Sent: 16/07/2019 11:40:46 AM
Subject: RE: Request for Services Progress - DA2018/1514 - Warringah Mall 145 Old Pittwater Road BROOKVALE - AMENDED PLANS
Attachments: 1611106 Stage 2 RMS Comments 190403.pdf;

RMS Reference: SYD18/01522/06

Council Reference: DA2018/1514

**RE: WESTFIELD WARRINGAH MALL REDEVELOPMENT AMENDED STAGE 2 DA
ADDITIONAL TRAFFIC MODELLING**

Figure 1: Standard Ingress/Egress on Condamine St (Option A)

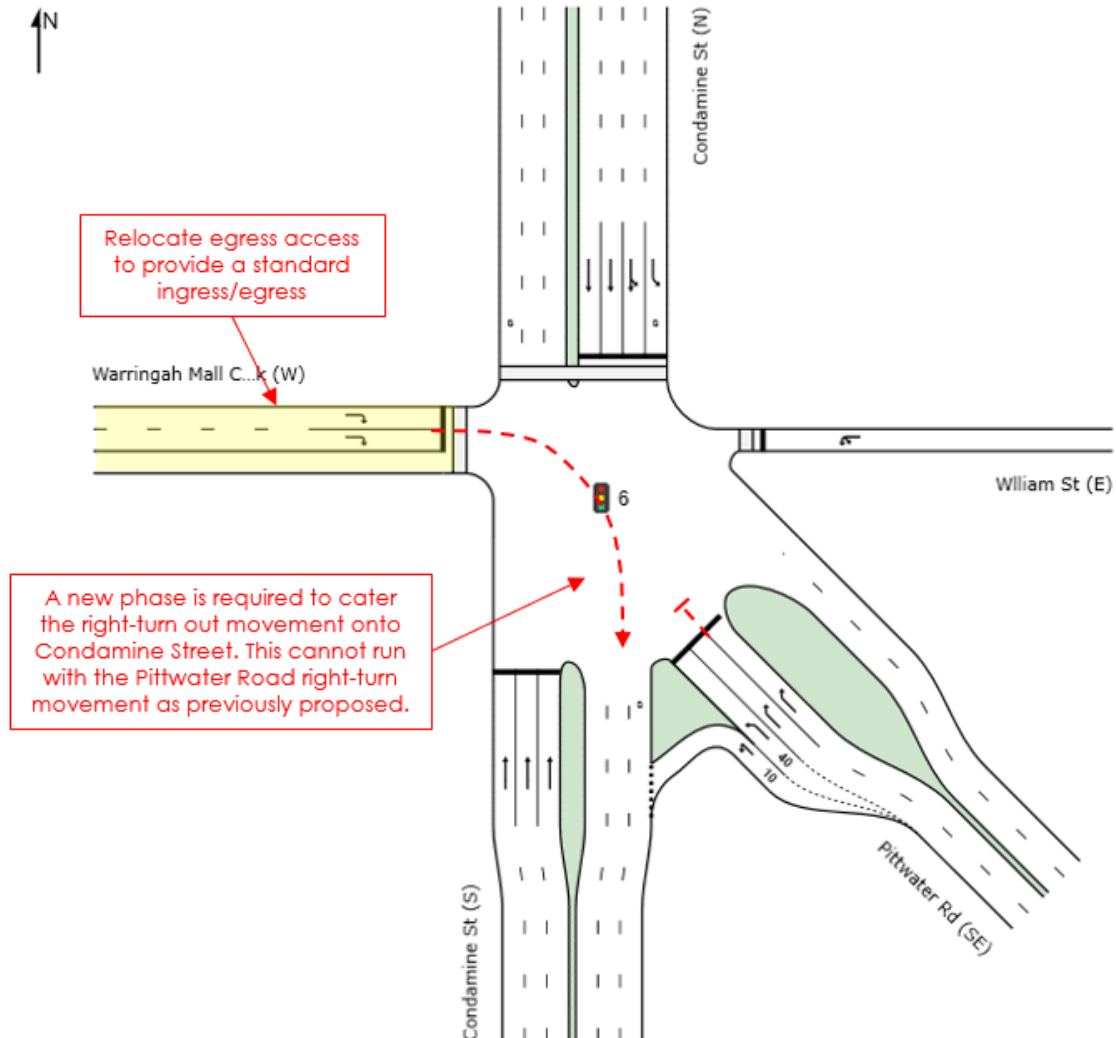
This option (Option A) reflects Roads and Maritime's comments to provide a standard ingress and egress arrangement. Under this option, an additional signal phase would be required to cater for the right-turn egress movement onto Condamine Street. This means less green time for existing movements at this Condamine Street-William Street intersection, which may not be supported by Roads and Maritime.

- Option A involves providing a standard ingress/egress access on Condamine Street as requested by Roads and Maritime would result in unsatisfactory intersection performance (LoS F) at the Pittwater Road-William Street intersection as a new signal phase is required to accommodate right turn movements out onto Condamine Street. Extensive delays and queuing will also be experienced for vehicles exiting the Centre onto Condamine Street. To address this issue, additional green time would be required to accommodate Centre related traffic. This means less green time on Pittwater Road and Condamine Street, which is unlikely to be supported by Roads and Maritime as it would affect the signal coordination on Pittwater Road. This is applicable to both Scenarios 5 and 6.

3. Amended plans are to be provided to show the proposed egress on Condamine Street to be relocated so that the intersection is presented with a standard entry/egress. Increased red times are also required on signal phases if the stop line is to be relocated.	Based on the updated traffic modelling, it is recommended that an egress only access be provided on Condamine Street. This means that the existing ingress access would need to be removed to provide a standard egress arrangement, as per Roads and Maritime's comments. It is however noted that a new ingress access on Pittwater Road between William Street and Cross Street is required to maintain an acceptable intersection performance at Pittwater Road-Cross Street intersection.

Figure 2: No Egress on Condamine St (Existing Access Arrangements, Option B)

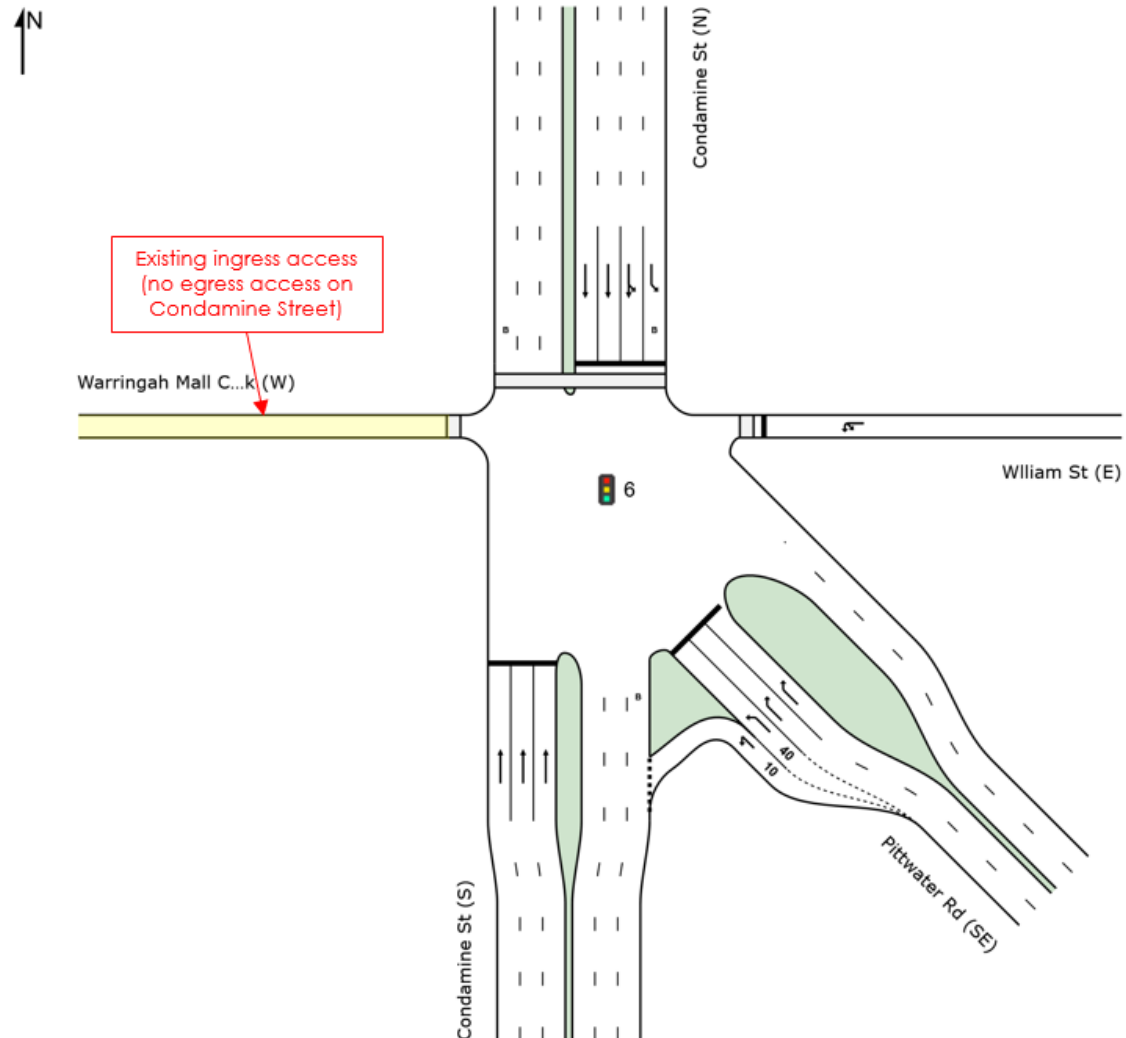
In the email to the applicants traffic engineer Michael Lee (Dated 13/05/2019) Roads and Maritime provided in-principle support for Scenario 6B (Option B with the one way access at Dale Street pg 7 of the attachment). Scenario 6B resulted in the preferred network and safety outcomes from a Roads and Maritime perspective. At this time Roads and Maritime requested that the development application plans be updated to reflect Scenario 6B. The plans submitted to Roads and Maritime by Council on the 26 June 2019 still show two way access at Dale Street (on the landscape plans) which is not in accordance with our advice. The architectural and civil plans are to be updated to reflect Scenario 6B.

- Option B examines an access arrangement in which there is no egress to Condamine Street and traffic wanting to travel southbound would do so via the existing vehicle access arrangements on Cross Street. This would result in traffic capacity issues on Cross Street between Green Street and Pittwater Road. This unsatisfactory network performance is unlikely to be supported by Roads and Maritime. Additional lane capacity on Cross Street would need to be considered between Dale Street and Pittwater Road, particularly the right-turn lane capacity onto Pittwater Road. These changes will require land to be provided to Roads and Maritime on Cross Street and Pittwater Road site frontages. However, both the Green Street and Dale Street would continue to experience traffic capacity stress with or without the Cross Street additional capacity discussed above. These issues exist in Scenario 5 and 6.

Additionally an updated Traffic Impact Assessment which proposes Scenario 6B is to be submitted to Roads and Maritime for review.

Figure 3: Egress Access only on Condamine St (Option C)

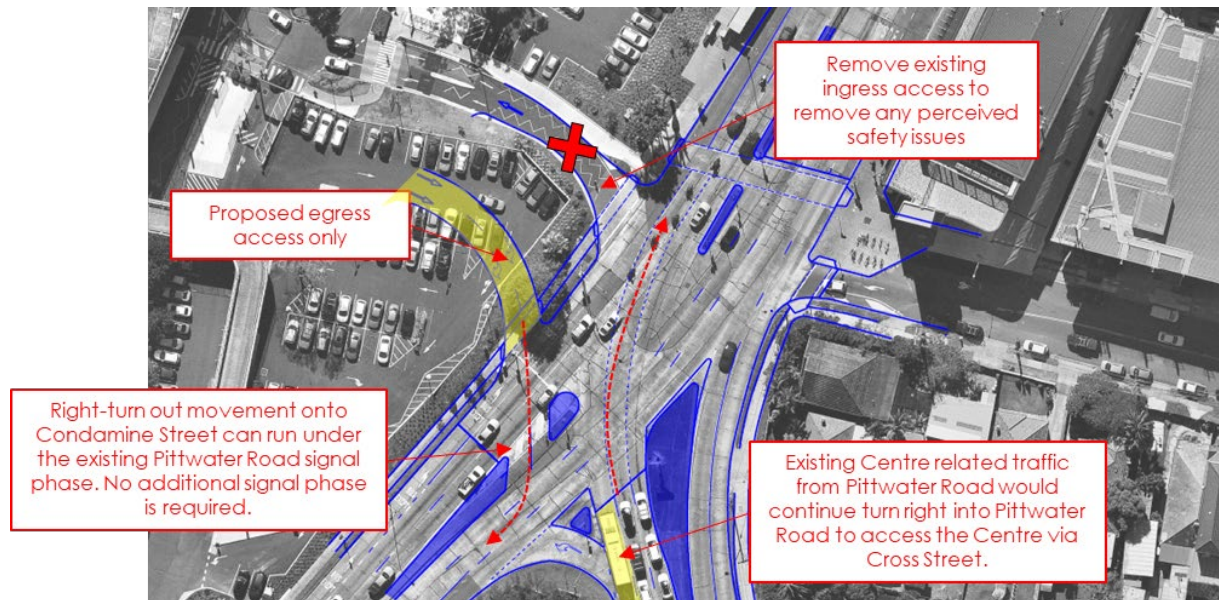
- Option C involves providing an egress access only on Condamine Street which is consistent with the previous proposal. However, this option also involves the removal of the existing ingress access on Condamine Street, opposite William Street, to provide a standard egress as requested by Roads and Maritime. This means traffic accessing the Centre from Pittwater Road (south) that used to rely on the ingress opposite William Street would do so in the future via Cross Street. This would result in an increased left-turn demand on Pittwater Road (south) onto Cross Street (west) which already operates poorly due to traffic capacity issues on Cross Street. This option would require a new (un-controlled) left turn slip lane provided on Pittwater Road (south) at Cross Street to maintain an acceptable intersection performance at the Pittwater Road-Cross Street intersection. The above identified issues relate to both Scenarios 5 and 6.

Any safety issues identified by the road safety audit that can not be satisfactorily resolved, an alternative option would be to revert to Option C as assessed in this letter. This option, as it removes the existing ingress, does not have any safety concerns raised by Roads and Maritime and would also provide satisfactory intersection performance.

Figure 4: Proposed Dale St Two-Way Arrangements (Scenario 5)

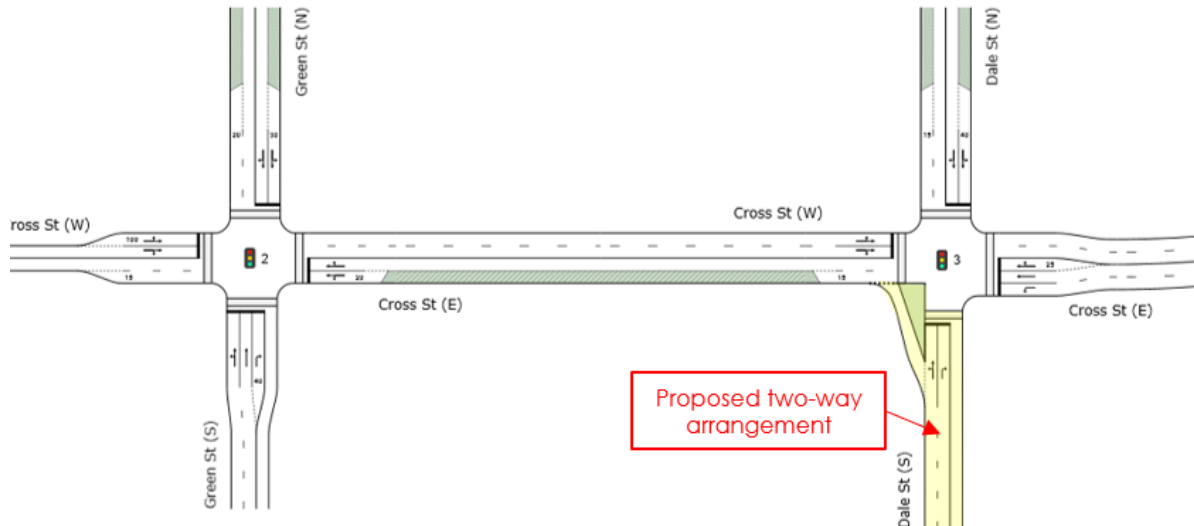
- The option to convert Dale Street to two-way will assist alleviate traffic demand at the Green Street access onto Cross Street in Options A and C. In Options A and C, this is not expected to result in any adverse traffic issues on the network as the model indicates that eastbound queues on Cross Street on approach to Pittwater Road do not (on average) queue beyond the Dale Street access.

5. The proposed Dale Street two-way conversion will affect southbound right-turn traffic from Dale Street into Cross Street. Vehicles may also not be able to turn out from the Centre onto Cross Street due to limited storage capacity for eastbound traffic on Cross Street between Pittwater Road and Dale Street.	The modelling indicates that there would be some downstream queueing on Cross Street on approach to Pittwater Road during "heavy egress periods". This issue is exacerbated if no egress access on Condamine Street can be provided. Notwithstanding this, if an egress access can be provided on Condamine Street, the model shows (on average), eastbound queues on Cross Street on approach to Pittwater Road do not generally queue beyond the Dale Street access. Additional right-turn lane capacity on Cross Street between Dale Street and Pittwater Road may need to be considered to address the "heavy egress periods" – i.e. the 85 th percentile queue length. However, overall, it is noted that the Cross Street-Dale Street access would continue to operate satisfactory under one- or two-way access arrangements if an egress access is provided on Condamine Street.

Figure 5: Dale St One-Way Arrangements (Existing Conditions, Scenario 6)

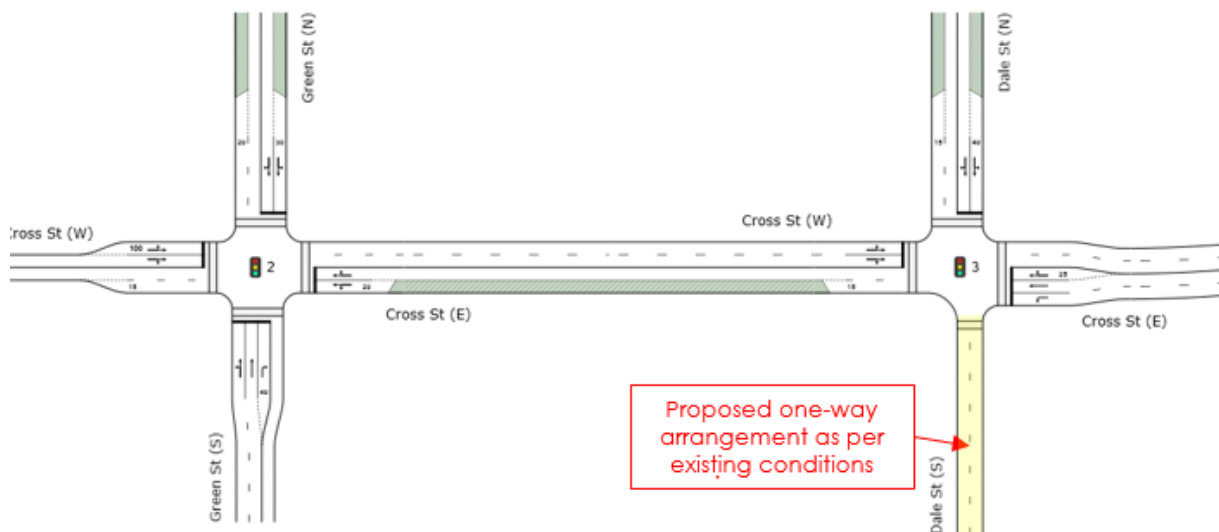
- The option to retain Dale Street as one-way will address Roads and Maritime's concerns regarding right turn issues from Dale Street onto Cross Street. The modelling shows that the additional traffic generated by the Stage 2 development on the Cross Street access would continue to operate at a satisfactory level of service (LoS B) if an egress access is provided on Condamine Street. Otherwise, this access would operate poorly due to traffic capacity issues on Cross Street as outlined above.
